Amendment of Fig.8:

Fig. 8

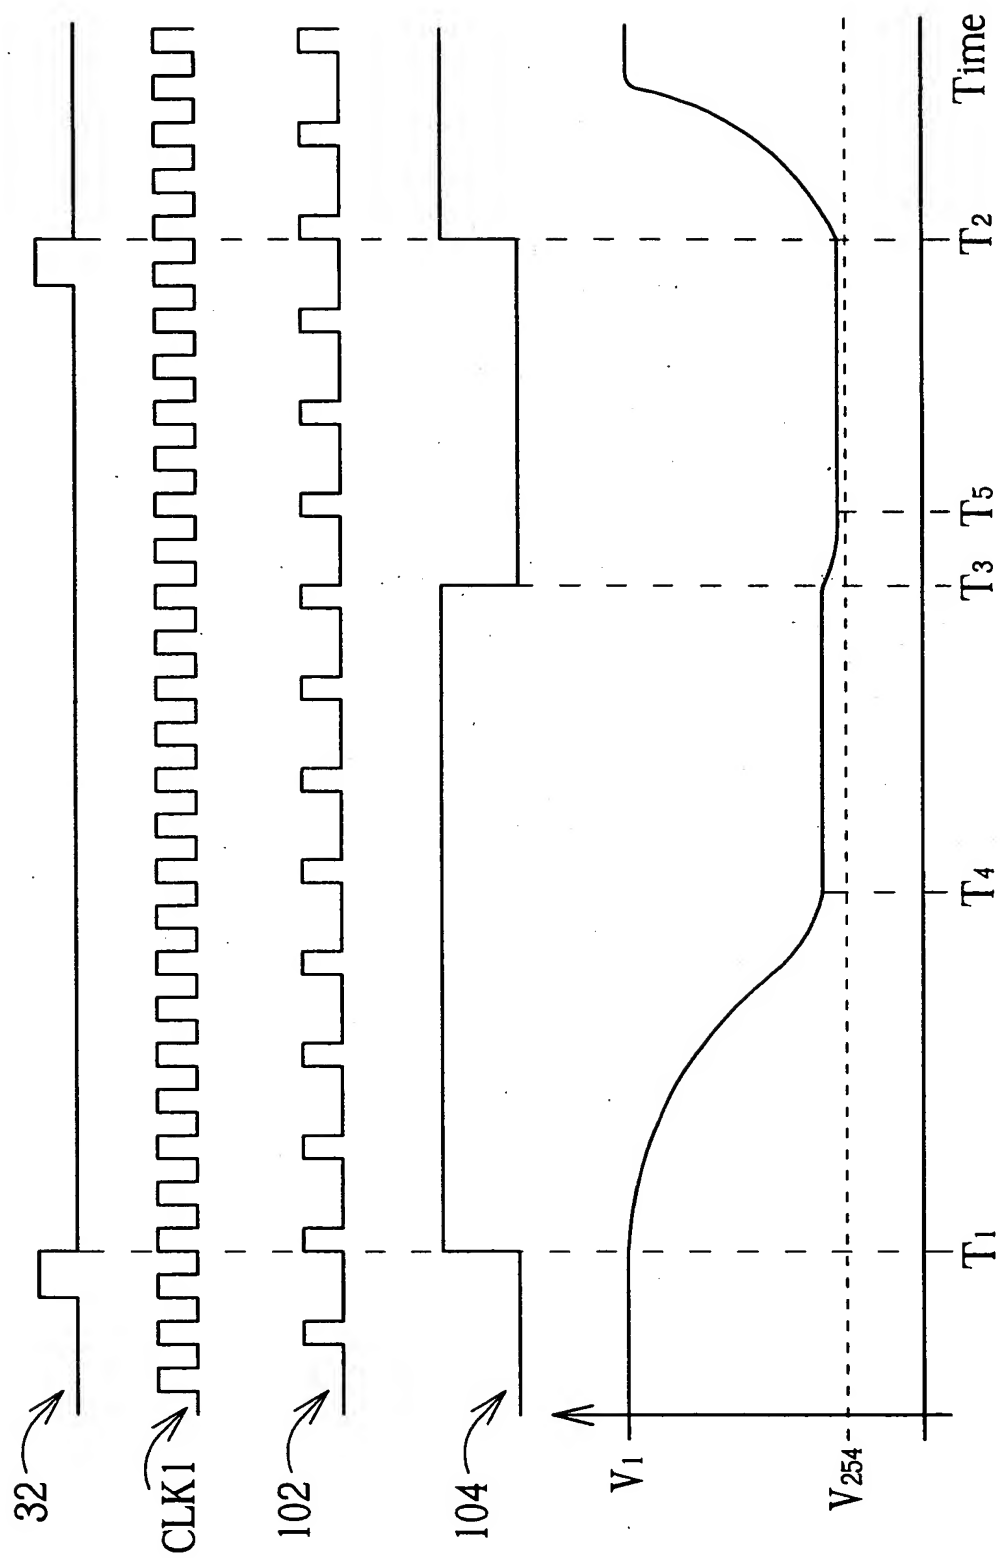
5 According to the amended Fig.8, only the fifth waveform shown
in the original Fig.8 is amended to better disclose art of
the present invention. Based on the amended specification (page

14), the actual driving voltage of the pixel may be deviated
10 so that the driving voltage inputted into the pixel will approach
voltage V_{254} after time T4. As shown in the amended Fig.8, the
pixel, therefore, is driven from voltage V_1 toward voltage V_{254}
during time T1 and time T3. In addition, the offset of the
operational amplifier is shown to deviate the actual driving
15 voltage. According to the originally filed specification (page

14), the voltages applied on pixels predetermined to be driven
to the same voltage level are averaged toward a voltage (V_2
for example) close to V_{254} after time T5. However, the averaged
voltage shown in the original Fig.8 becomes voltage V_2 that
20 is erroneously deviated from the voltage V_{254} . Therefore, the
originally filed specification is amended for changing V_2 to
 V_a . The voltage V_a is added to represent any voltage level
appropriately close to V_{254} according to the originally filed
specification. In addition, in order to precisely show that
25 the averaged voltage is appropriately close to the voltage
 V_{254} according to the preferred embodiment disclosed in the
amended specification, the averaged voltage shown in the
original Fig.8 is correspondingly amended. As shown in the
amended Fig.8, the driving voltage of the pixel becomes an
averaged voltage that is close to voltage V_{254} after time T5.

30 No new matter is introduced. In light of this amendment, the
subject matter that applicants regard as their invention is
more clearly and precisely described. Allowance of the amended
Fig.8 is hereby requested.
